**TOWN OF ADDISON
BUILDING REPORT**

Facility Information: **Facility Name:** Conference Centre
Facility Contact: Lisa Pyles **Contact Phone:** 972-450-2878

Accessology Inspector Information:
Inspector: Karen Jackson **Date:** April 19, 2017
Email: Kjackson@accessology.com

Latitude: 32.961751 **Longitude:** -96.828638
Address: 15650 Addison Circle **City:** Addison **County:** Dallas

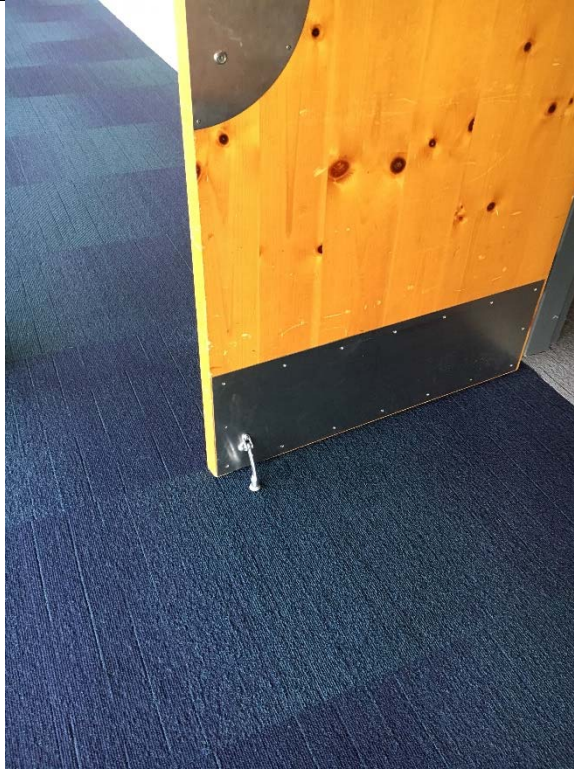
Violation 1 – The double doors leading into the conference rooms (4 sets) have door stops at the bottom of each door.

Violation 2 – The route leading behind the reception desk is only 29” wide.

Violation 3 – There are 8 doors in this facility that have knob type door hardware that requires grasping and twisting to operate.

Violation 4 – The Men’s restroom does not have a minimum of 54” deep maneuvering clearance provided on the pull side of the door.

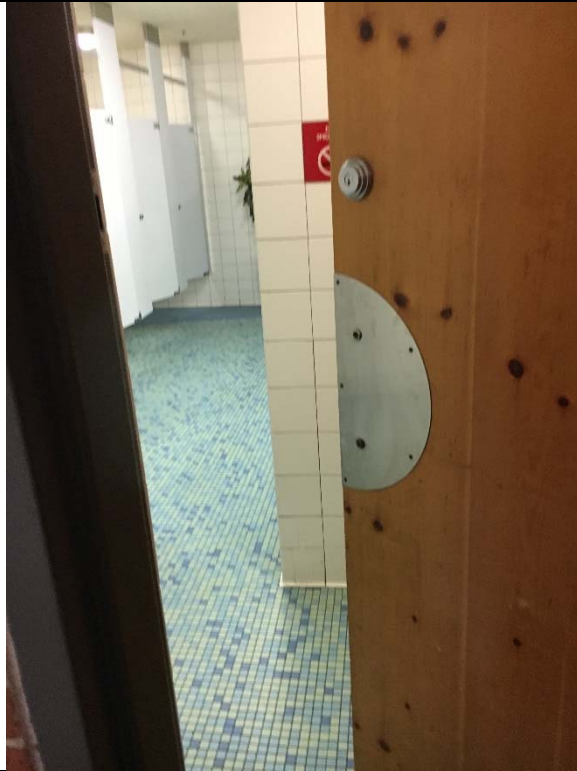
Violation 5 – The Men’s restroom has eight (8) fixtures and no ambulatory toilet compartment.

Violation 6 - The Women's restroom does not have a minimum of 54" deep maneuvering clearance provided on the pull side of the door.

Violation 7 - The Women's restroom has seven (7) toilet compartments and no ambulatory stall.

Violation 8 - The work room behind the reception area only has a 28.5" door opening with a 5.5" maneuvering clearance provided on the pull side of the door.

Violation 9 - The storage room behind the reception area only has a 29" door opening with a 10 1/4" maneuvering clearance on the pull side.

Violation 10 - There is a wing wall in the storage room behind the reception desk that reduces the room size to 29.5" wide obstructing full access into the room.
